Portfolio Holder Decisions/Leader Decisions

The Warwickshire County Council (Coton Bridge, Coton Road, Parish of Nether Whitacre) (Weight Restriction) Order 2021

1.1 A copy of plan TR-11220 detailing proposals for an 18 tonnes weight limit on Coton Bridge can be found as Appendix B. Objections and comments were received to these proposals; the following tables detail the objections and comments received together with the officers' responses.

Drawing number
TR/11220

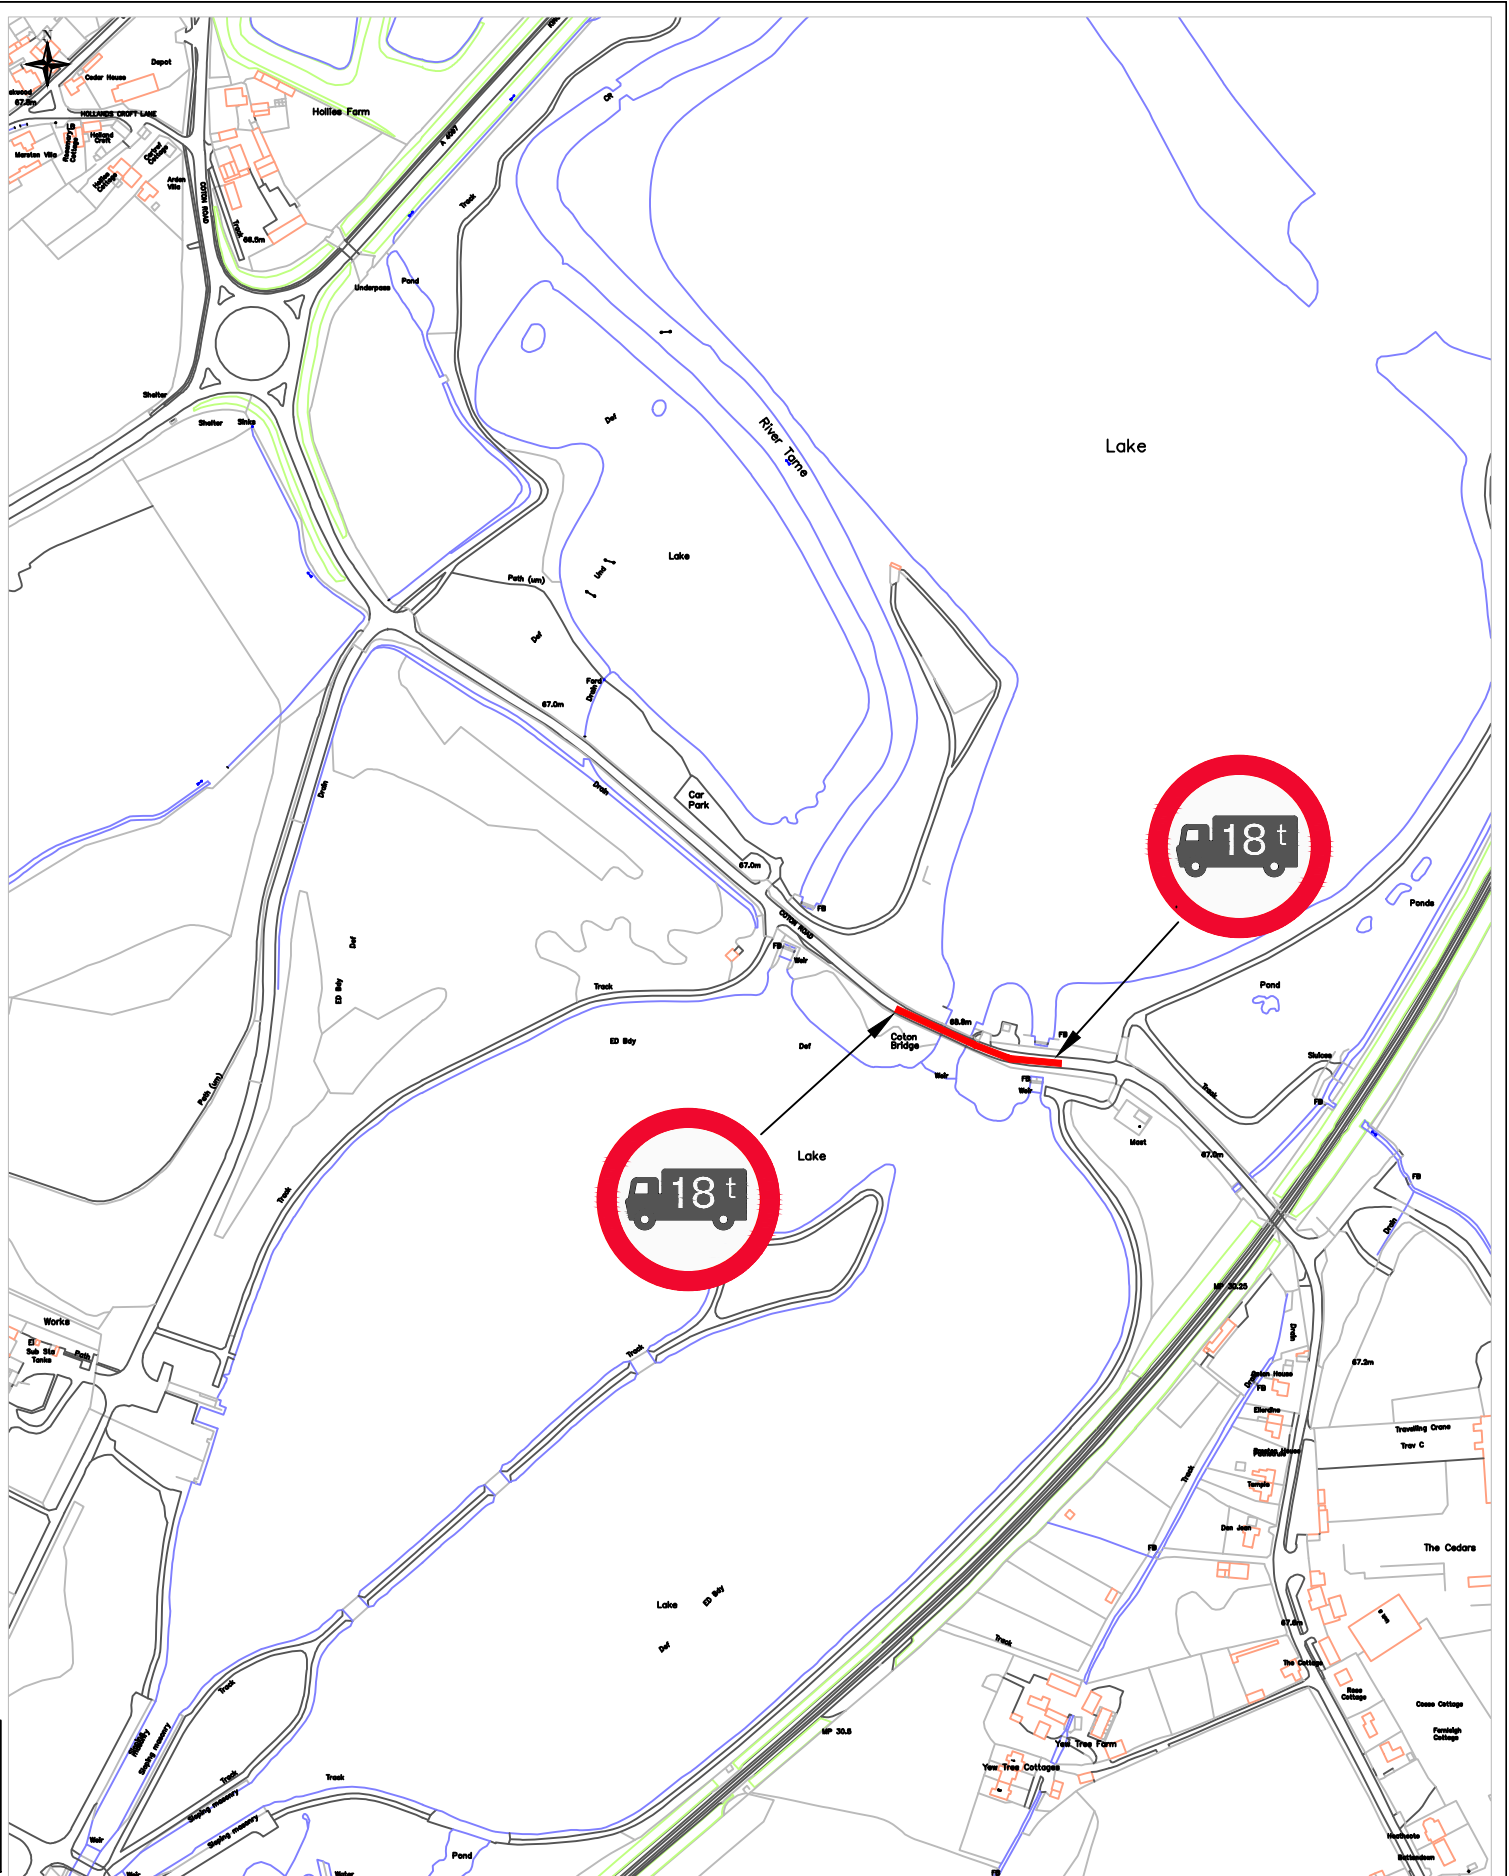
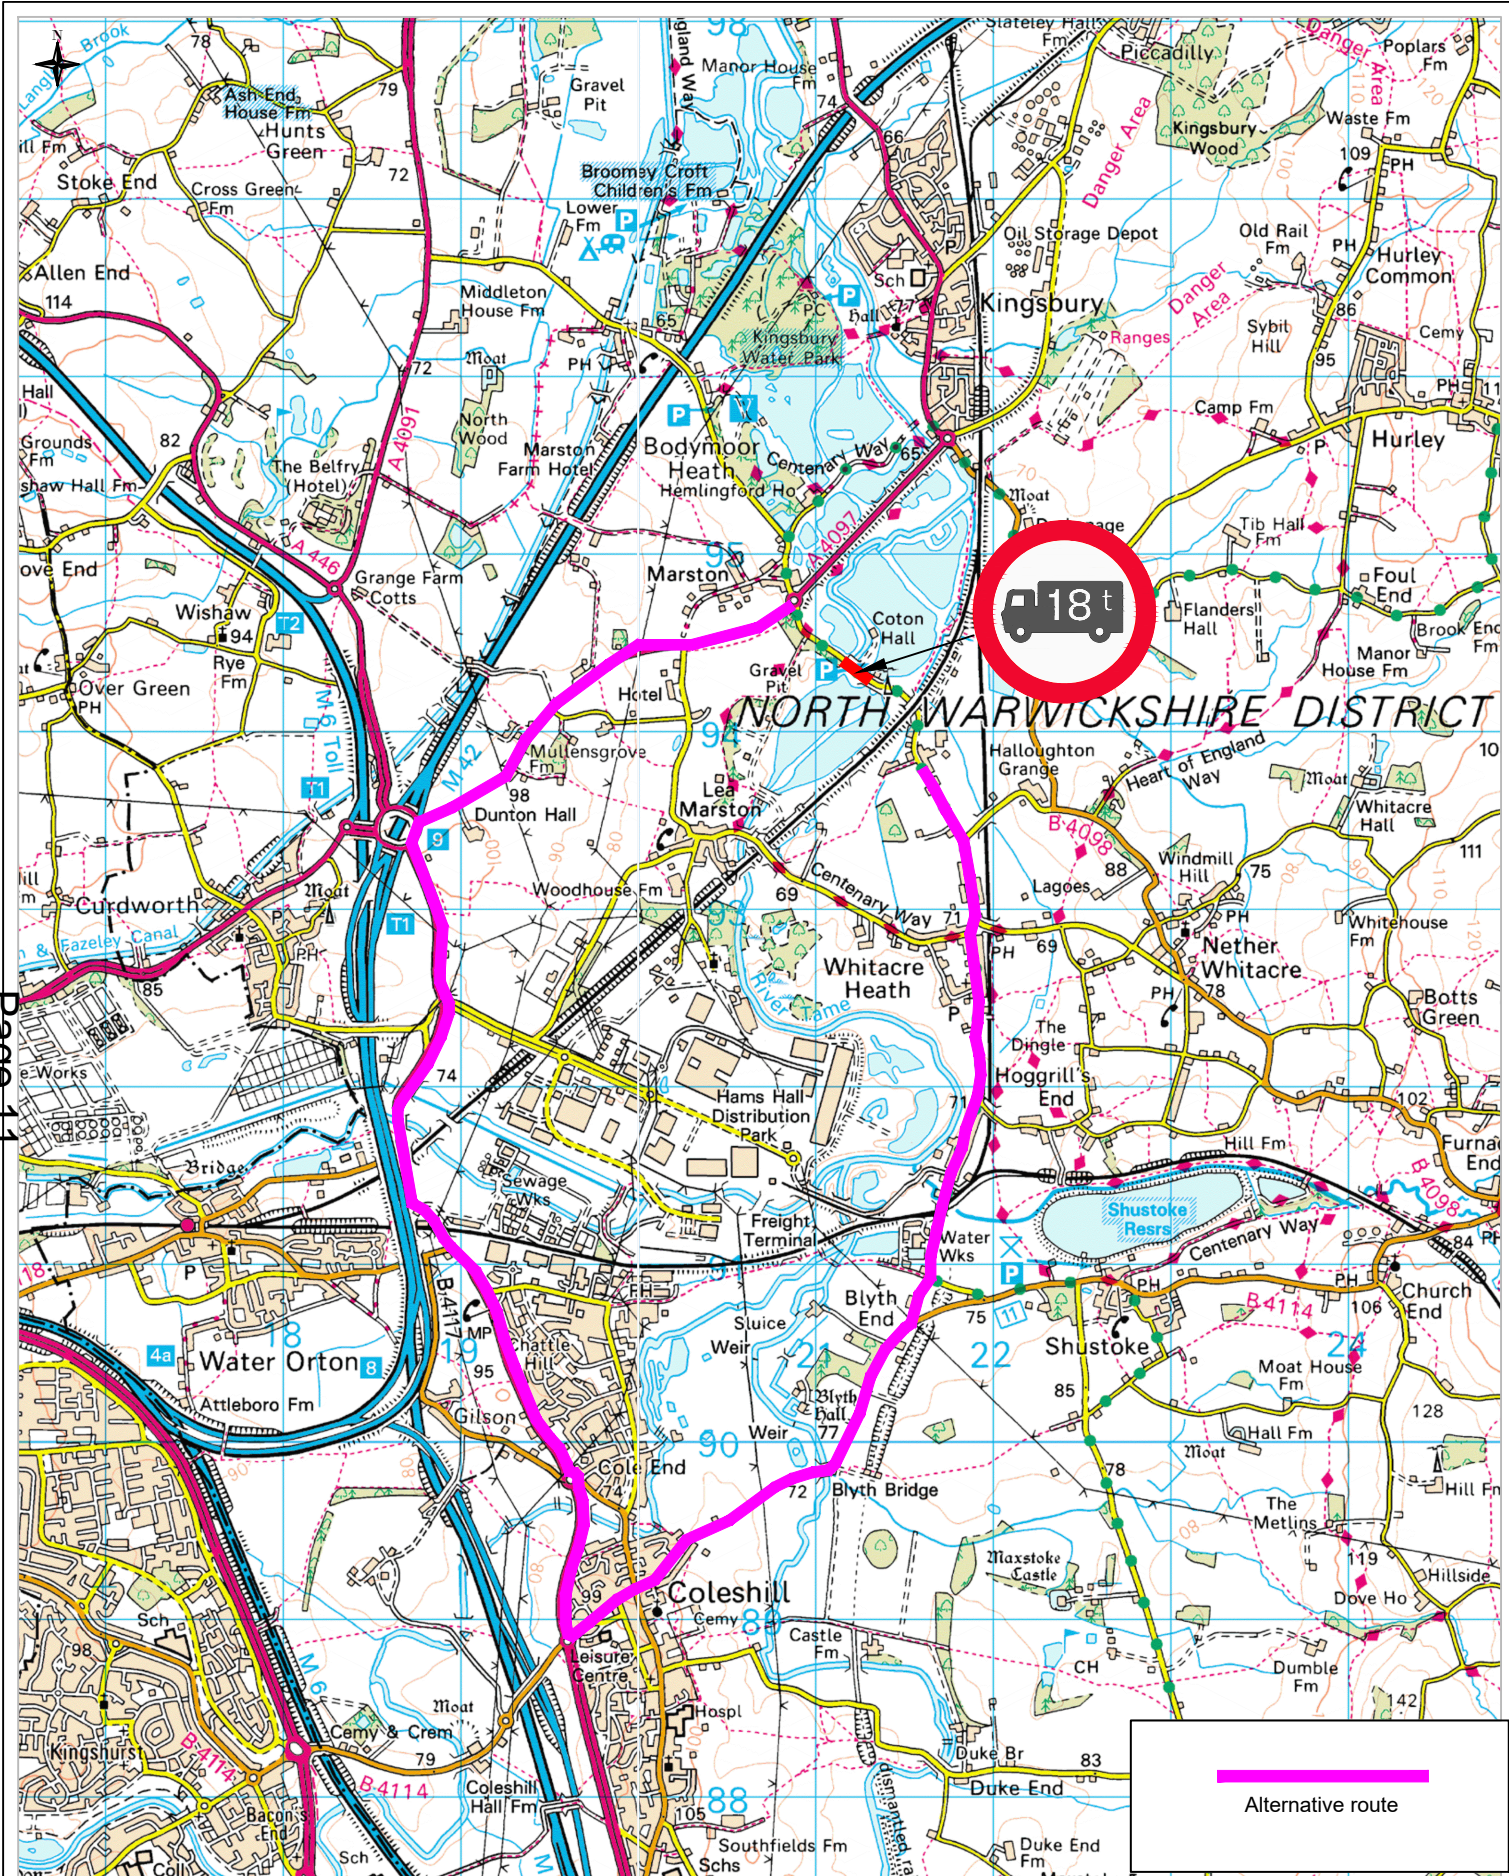
The alternative route is far longer than 5km, (see plan ref. TR/11220) Through a renowned hot spot of the Coleshill crossroads, straight through the spine of the village to the Cedars. The

On reading through the paperwork regarding the proposed weight restrictions and the alternative routes that have been advised (**A4097 Kingsbury Road – A446 Lichfield Road – B4114 Birmingham Road/Blythe Road – Station Road – Coton Road (see plan ref. TR/11220)**)
